# UNITED STATES PATENT AND TRADEMARK OFFICE

APPLICATION NO.	FILING DATE	FIRST NAMED INVENTOR	ATTORNEY DOCKET NO.	CONFIRMATION NO.
10/780,082	02/17/2004	Michael L. O'Banion	0275Y-625COD	9514

**Office Action Summary**

Top plan view of  
fastener

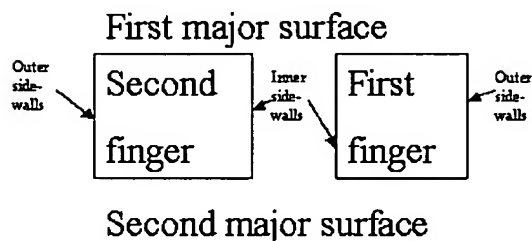
3. Examiner is assuming, based on an interview with attorney in related case 10/780072, that the major surfaces and sidewalls are arranged as below:

4. Fig 4 should be described as a front view, not a side view, if Fig 3 is a side view.  
Examiner assumed teeth not labeled are teeth 40.
